Model: CM-C1	Date: 12-Jan-06	No.: RB273001a
--------------	-----------------	----------------

Subject: Countermeasure for poor image quality		Prepared by: T. Shintani	
From: 1st Tech. Support Sec. Service Support Dept.			
Classification:	<input checked="" type="checkbox"/> Troubleshooting	<input type="checkbox"/> Part information	<input type="checkbox"/> Action required
	<input type="checkbox"/> Mechanical	<input type="checkbox"/> Electrical	<input type="checkbox"/> Service manual revision
	<input type="checkbox"/> Paper path	<input type="checkbox"/> Transmit/receive	<input type="checkbox"/> Retrofit information
	<input type="checkbox"/> Product Safety	<input type="checkbox"/> Other (      )

Model: Model CM-C1		Date: 1-Feb-06	No.: RB273002
Subject: Limitation for using the USB memory stick		Prepared by: T.Shintani	
From: 1st Tech. Support Sec. Service Support Dept.			
Classification:	<input type="checkbox"/> Troubleshooting <input type="checkbox"/> Mechanical <input type="checkbox"/> Paper path <input checked="" type="checkbox"/> Other (      )	<input type="checkbox"/> Part information <input type="checkbox"/> Electrical <input type="checkbox"/> Transmit/receive	<input type="chec

## 3.19 Network Board

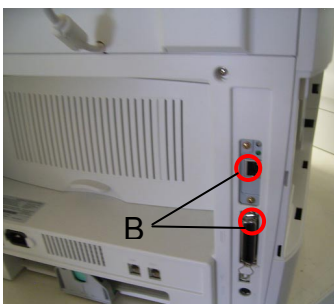
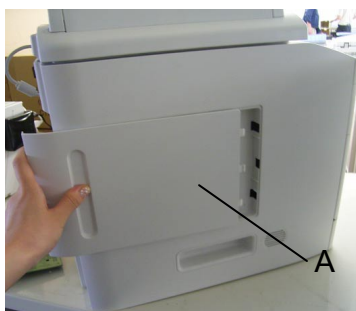
- **Add** the replacement procedure for the network board.

1. Open the side cover (Cover – Memory) [A].

2. Remove the 2 screws [B].

3. Remove the network board [C].

4. Close the side cover (Cover – Memory) [A].

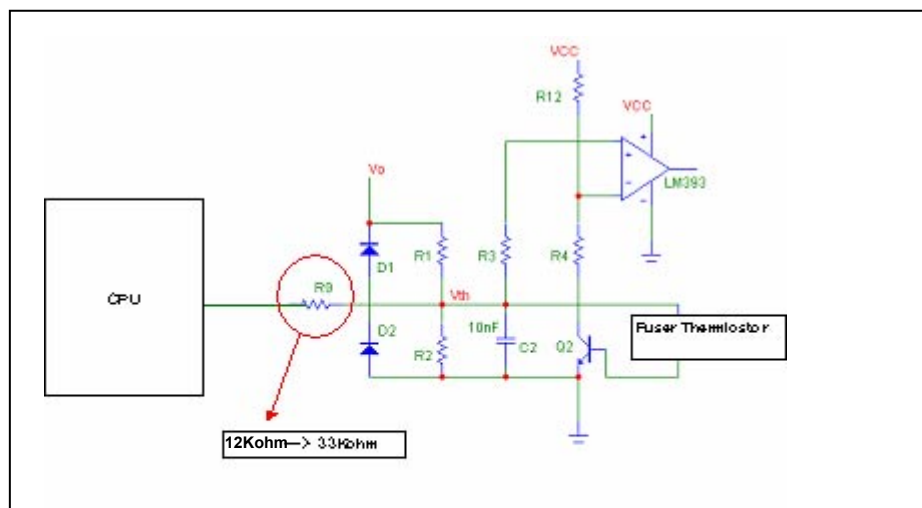
If the machine receives abnormal electrical noise (which can be generated by surges or static electricity), it may cause the fusing unit to malfunction.

1. Abnormal noise causes the CPU to lock up, and once it's locked up, it cannot control the temperature of the fusing lamp.
2. Electronic noise due to electrostatic charge on the paper could potentially interfere at the input point of fusing unit controller.

1. Change the R9 resistor on ADC port from 12 Kohm to 33 Kohms. The hardware protection temperature is reduced by about 100 degrees.

The following schematic shows the resistor that must be changed.

## 7.FRAME ASSEMBLY (B273)

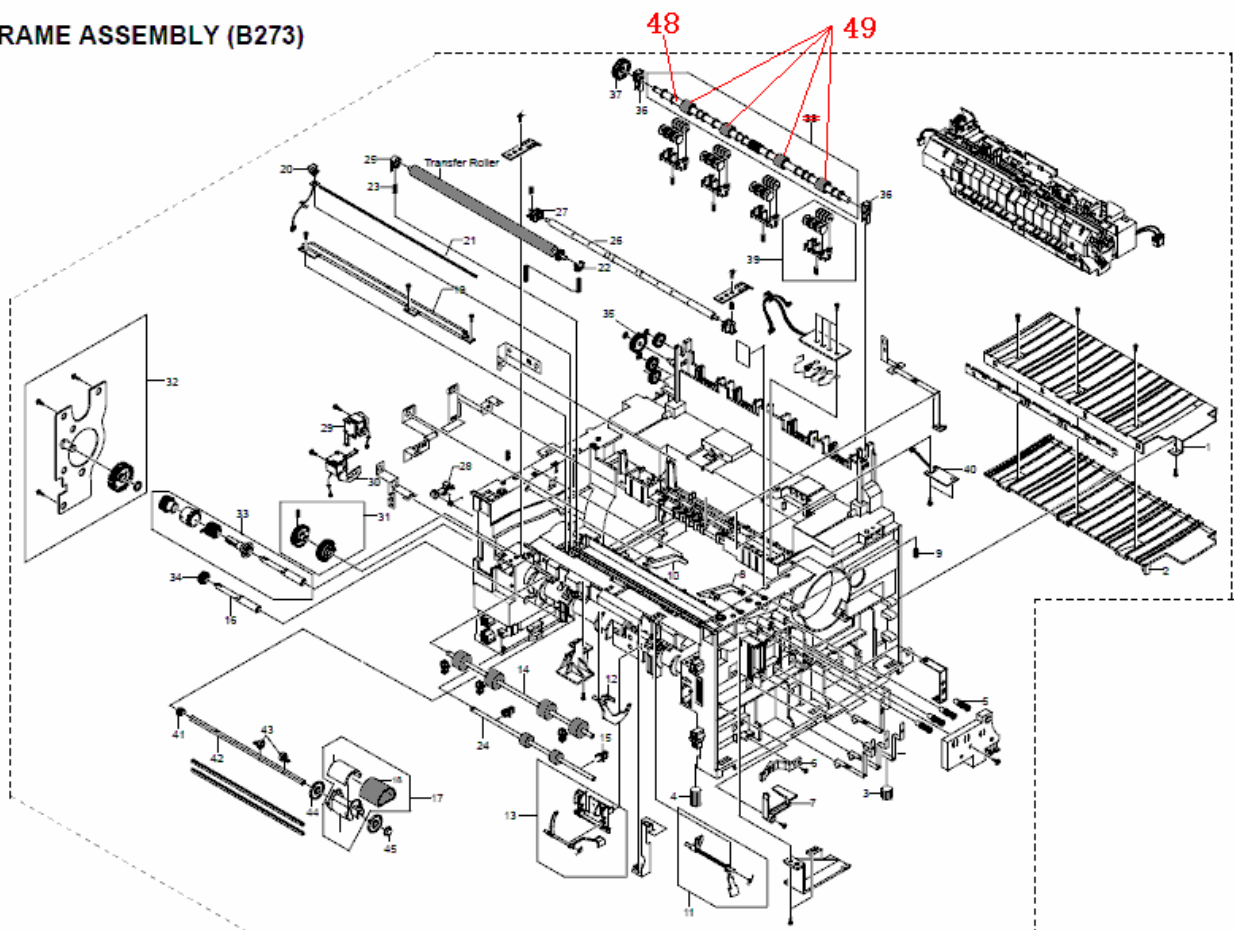
**Change:** The assembly in the table below (P/N H9149725) was divided into two parts.

**Reason:** The Parts Catalog was corrected.

Old Part Number	New Part Number	Description	Q'ty	Int	Page	Index	Note
H9149725	H9149725	EXIT ROLLER POLE	1	O/O	14	38→48	
	G1449752	EXIT ROLLER	4			38→49

## 1.OPTIONAL PAPER FEED UNIT ASSEMBLY

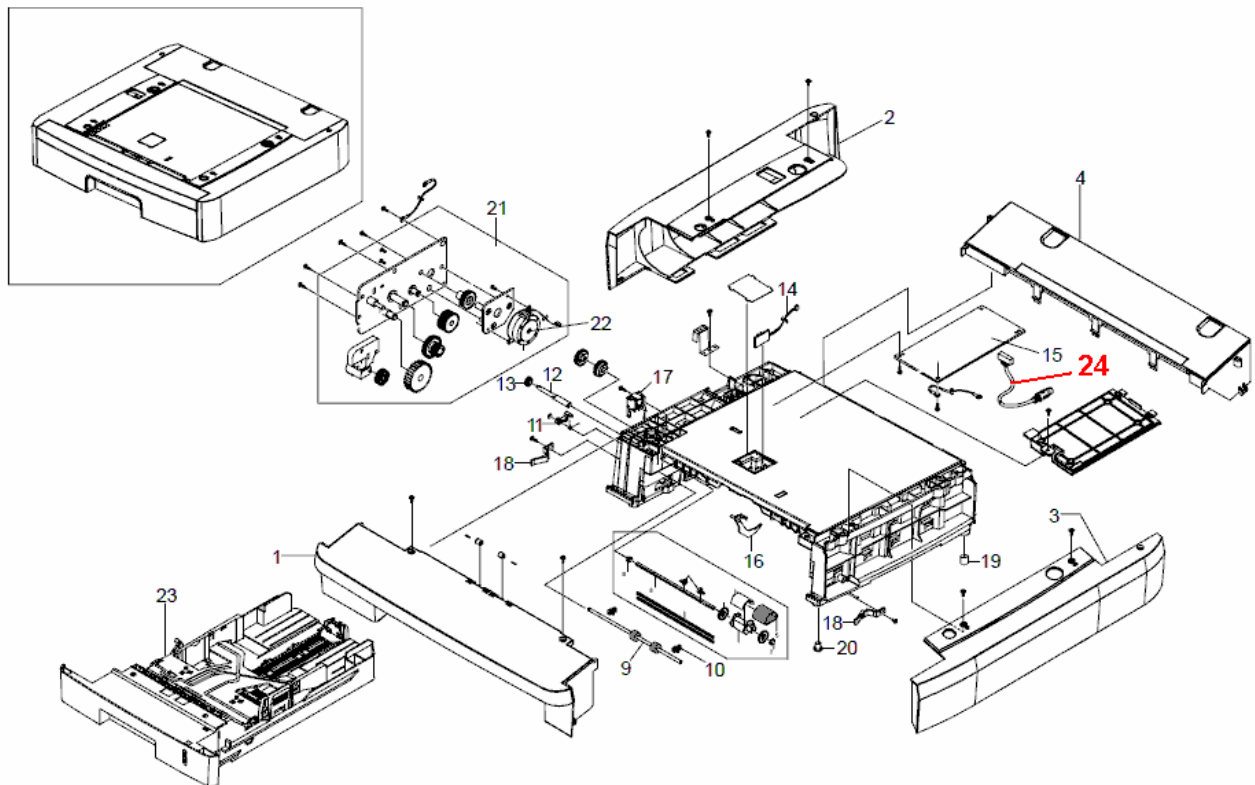
**Change:** This part was added.

**Reason:** Requests from the field.

NEW Part	Description	Q'ty	Int	Page	Index	Note
H2389655	HARNESS - PFU	1	-	3	24

### 8.FUSING UNIT ASSEMBLY (B273)

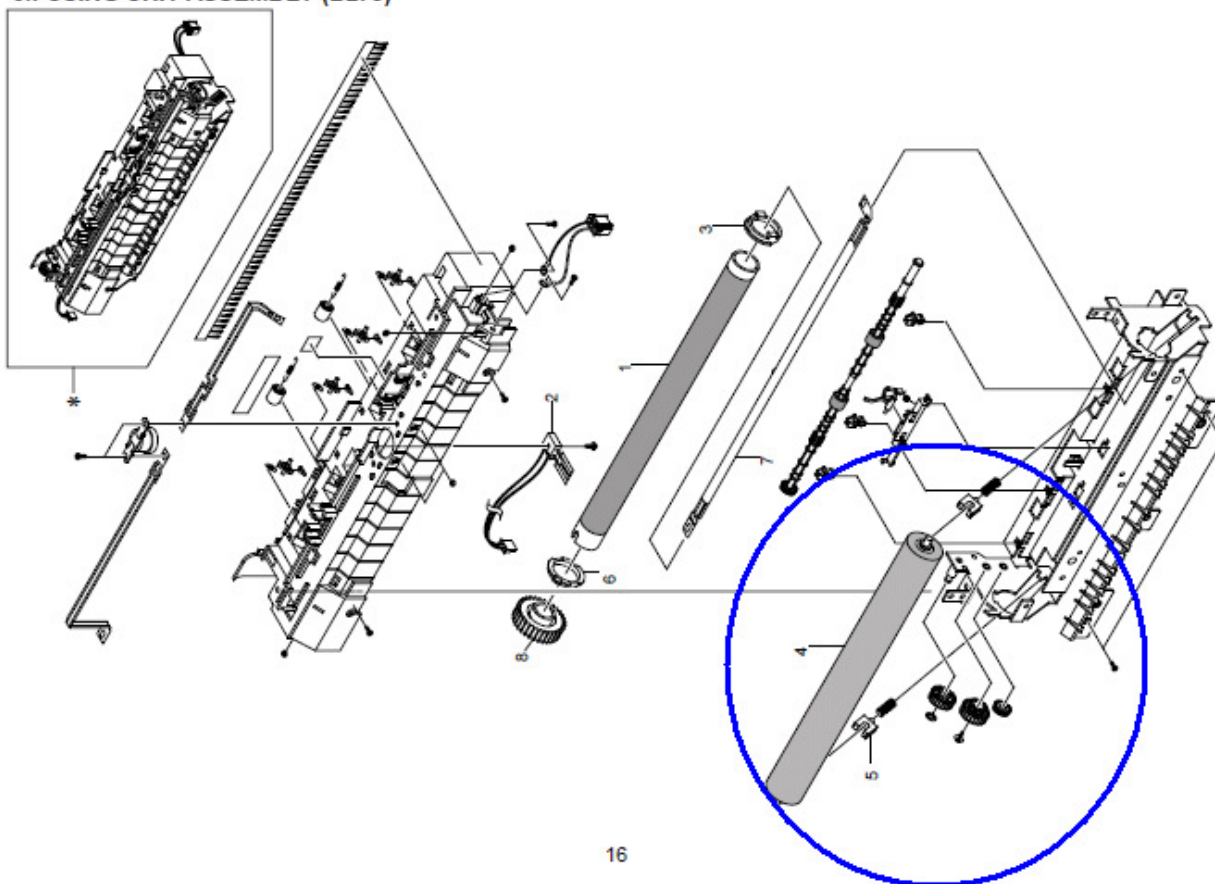
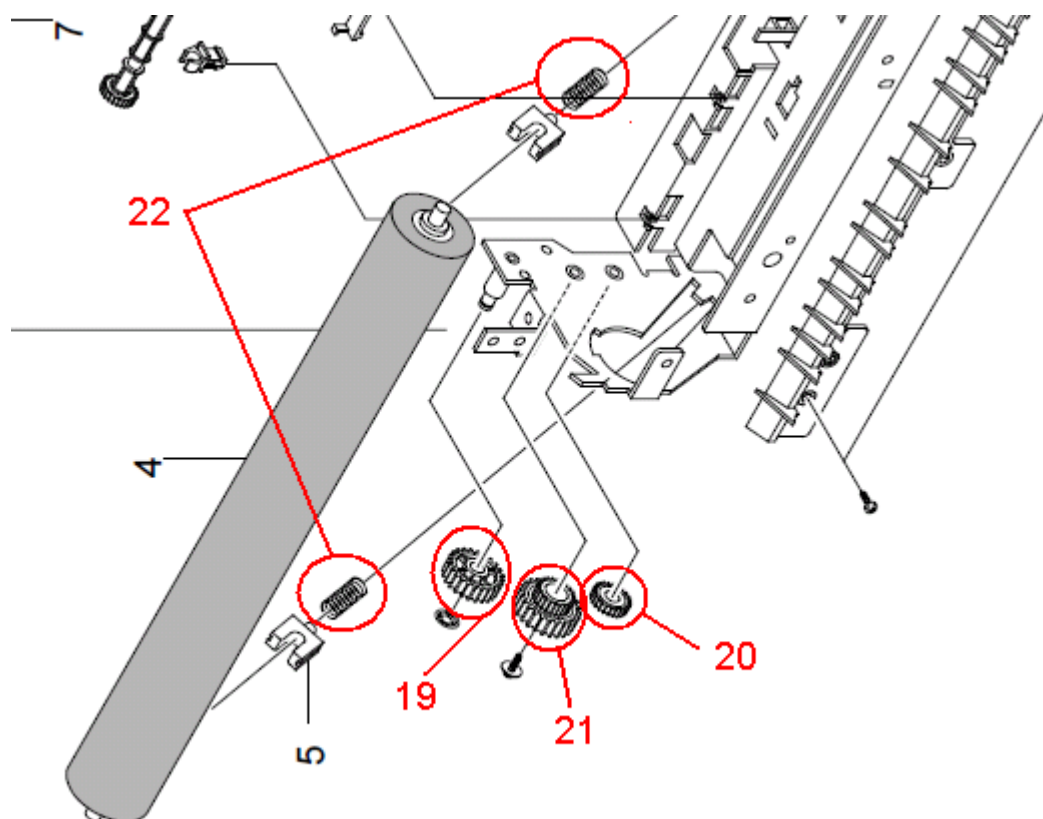
The following service parts are added.

Requests from the field.

New Part #	Description	Q'ty	Page	Index	Note
G9601101	IDEAL GEAR MA ASS'Y (RoHs)	1	17	19	
B1739804	GEAR DRIVE16	1	17	20	
G1449609	GEAR 25/15	1	17	21	
G1449729	SPRING - BEARING	2	17	22
